# Nomad

# SERVICE BULLETIN

## FUEL SYSTEM – REWORK OF CHECK VALVES TO PREVENT DAMAGE TO BOOST PUMP ELECTRICAL LEADS

Figure 1 Fuel Check Valve MS28885-8

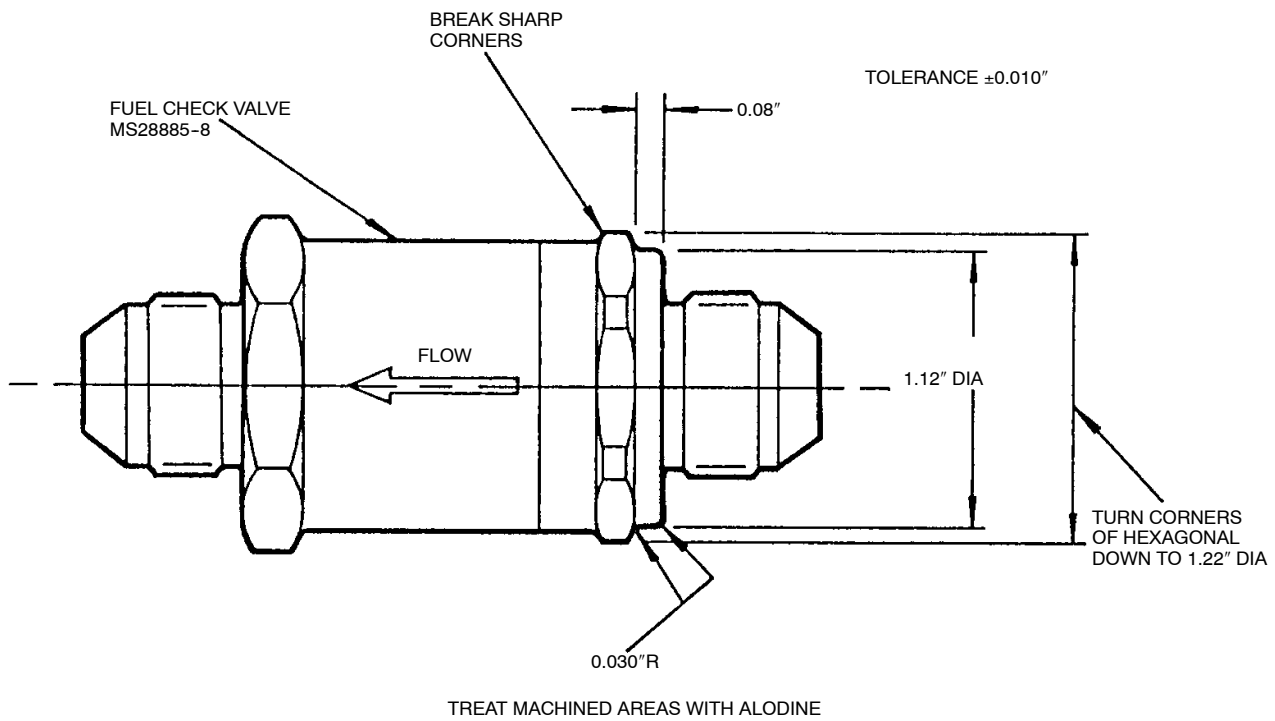
During assembly of check valve PN MS 28885-8 and Boost Pump PN1C6-14, the pump electrical leads can be damaged and cut by the sharp corners of the hexagonal end of the check valve body.

This Service Bulletin requires that the four check valves, PN MS 28885-8 in the left and right hand inboard fuel sumps be removed and reworked to avoid damage to electrical leads to fuel pumps PN 1C6-14.

- A. At both inboard fuel sumps remove, fuel check valves PN MS28885-8 as outlined in MM Chap 28-20-00 and rework inlet end of each valve by machining as shown in sketch below.

After rework treat machined surfaces with Alodine.

Ensure that electrical leads to boost pumps are undamaged and replace check valves as per MM Chap 28-20-00.
